# SITE PLAN & SIGN APPLICATION REVIEW

9/13/21 Plan Commission Meeting

## Signs & Lines by Stretch / Bliffert Germantown Holdings

Village Planner Report

**PROPOSED SITE PLAN**

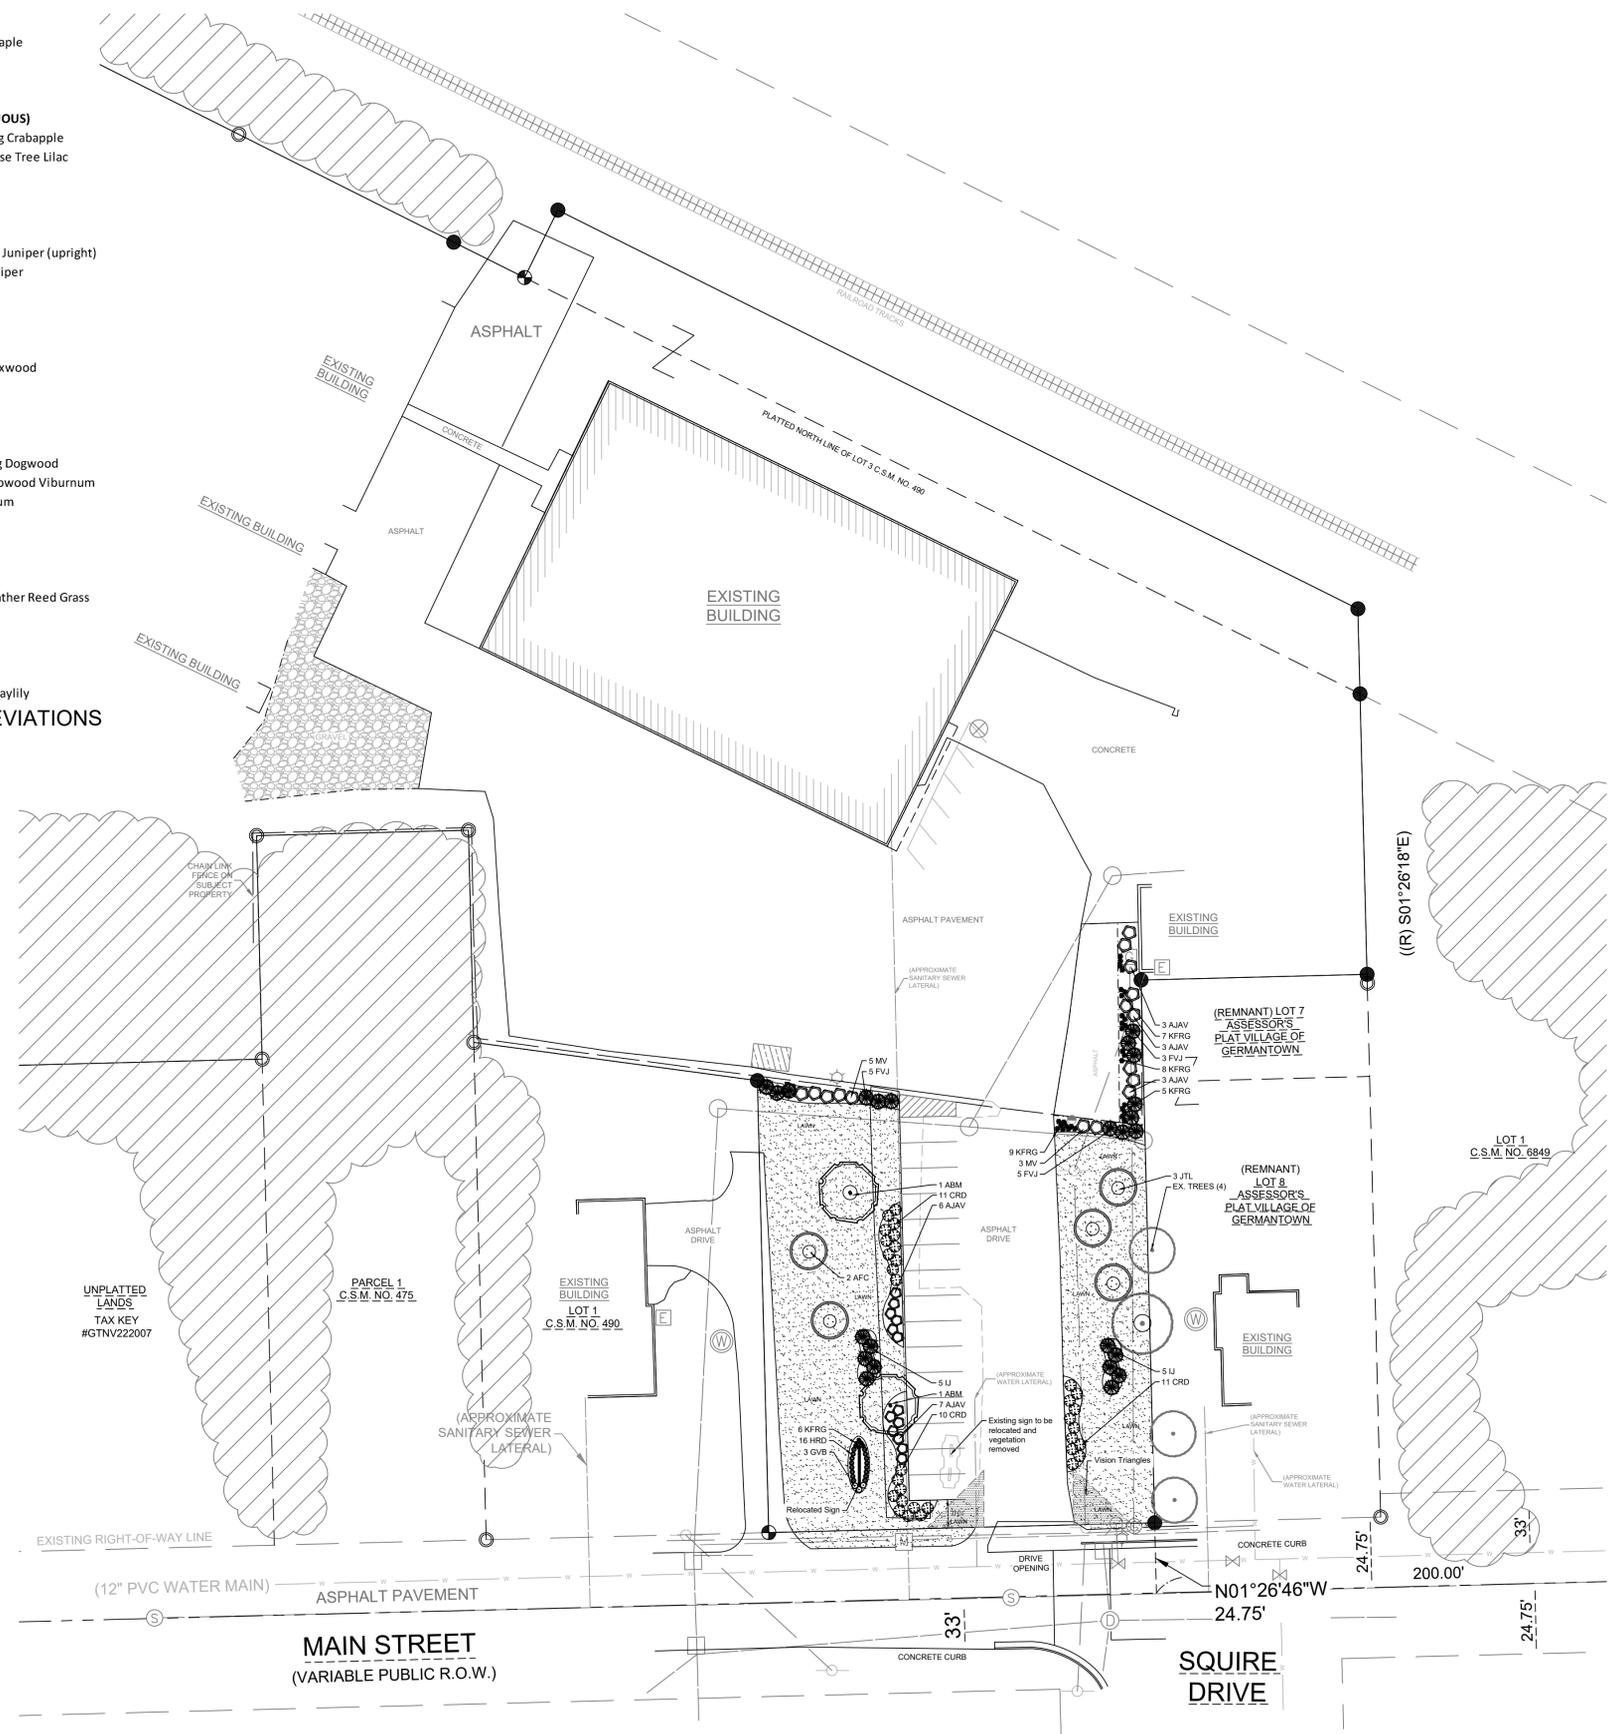
The applicant has approached staff with a revised site plan that includes parking stalls along the western edge of the access drive due to the need for additional parking on the site. Staff has worked with the applicant to revise the site plan and landscape plan to meet Village Code requirements.

Additional landscaping is proposed to the west of the parking stalls in order to better screen the parking area from the residential property to the west. Landscaping will include deciduous and evergreen trees, deciduous and evergreen bushes, ornamental grasses and perennials.

Chapter 17.45 of the Village Code requires that parking areas be setback a minimum of 50 feet from a residential district. The properties to the east and west of the entrance driveway are zoned Rs-5 Single-Family Residential. The originally approved site plan

did not include parking along the west side of the access drive and therefore there was less of a need to screen the area. Staff worked with the applicant to add landscaping that we believe is sufficient to screen the parking from the residential areas to the west and east.

The Fire Chief has indicated that the proposed parking on the west side of the access drive will not interfere with emergency vehicle access to the site in case of an emergency.

**APPROVE** the site development & landscape plans adding additional parking and landscaping to the property located at N116 W16474 Main Street subject to the following conditions:

- a. Civil Engineering plan dated August 27, 2021
  - b. Landscaping plan dated September 2, 2021
2. All landscaping, screening, grading, and paving improvements shown on the approved site plans shall be installed as proposed prior to issuance of an occupancy permit unless a cash bond or letter of credit in an amount equal to 120 percent of the estimated installation and material costs reviewed and approved by the Village is submitted to the Village as necessary to ensure that installation of the proposed features and improvements will be completed within one (1) year after issuance of the occupancy permit.

# ARTWORK APPROVAL

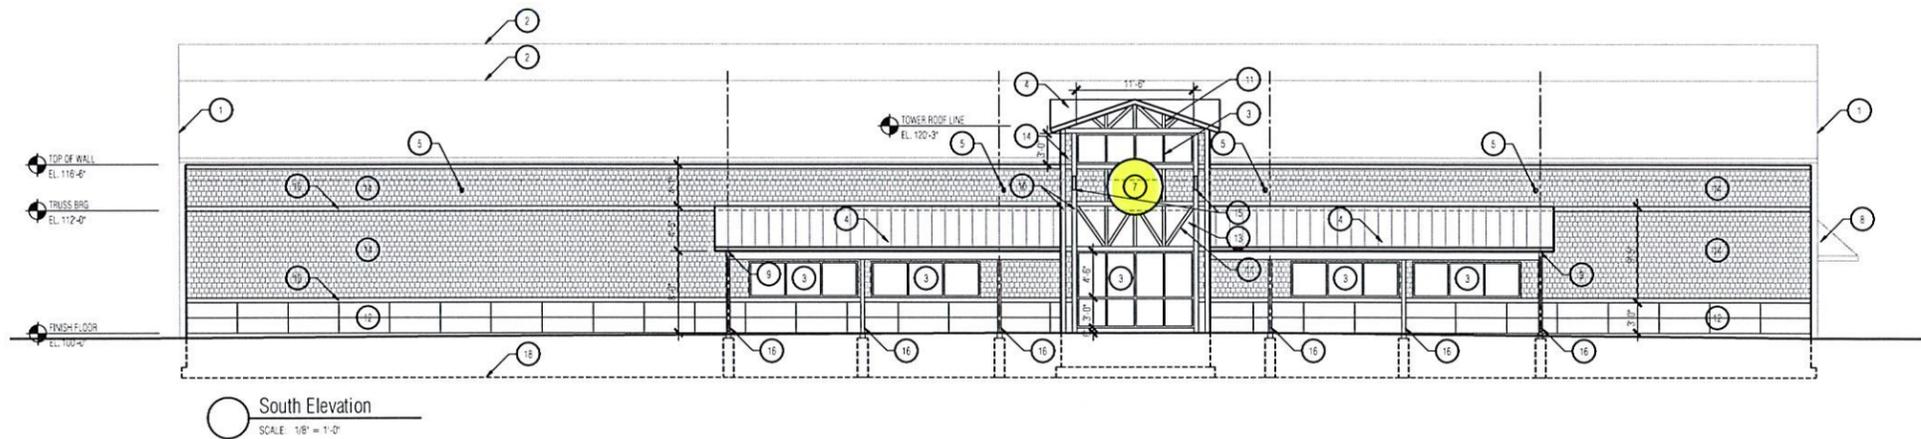
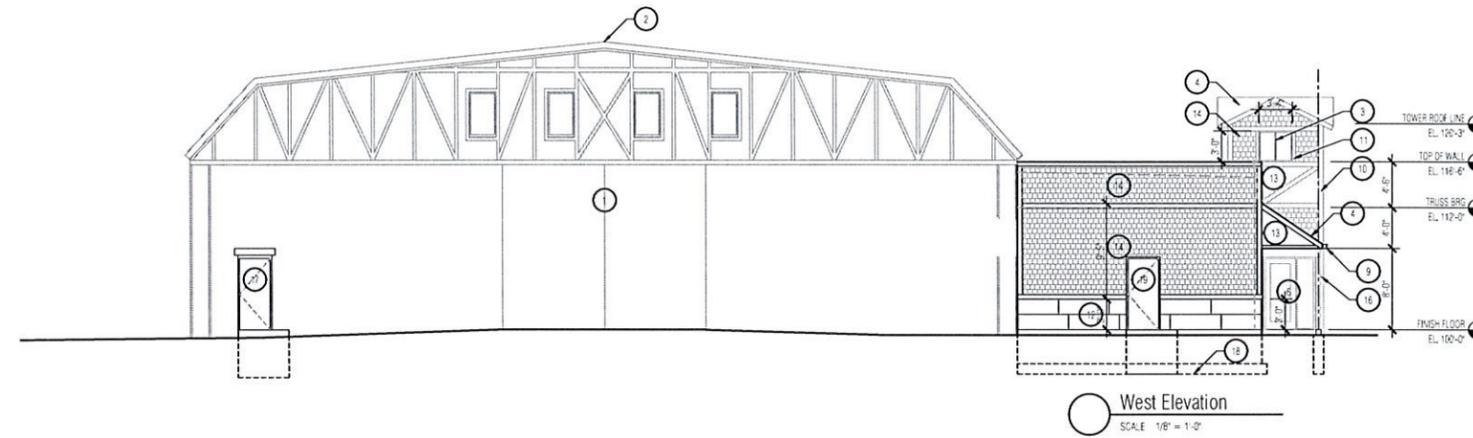
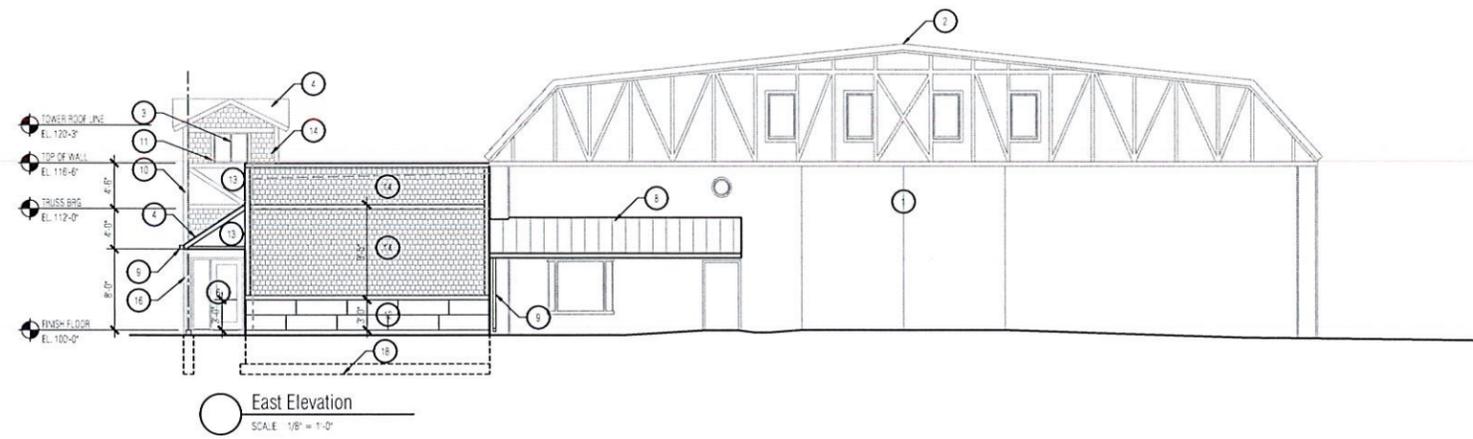
- 75" x 74" (39 square feet) aluminum and plastic sign, internally illuminated with opaque background, to be located on the south elevation over the entrance.
- 64" x 18" Sash "Baumarkt" (translation: hardware store) sign made of black dibond with light gold metallic cut lettering

The proposed signage meets code requirements.

**APPROVE** the proposed ground (monument) and wall signs for the Bliffert Lumber located at N116 W16474 Main Street subject to the following conditions:

1. Electrical permits shall be obtained from Inspection Services prior to installation of any/all electrical components.
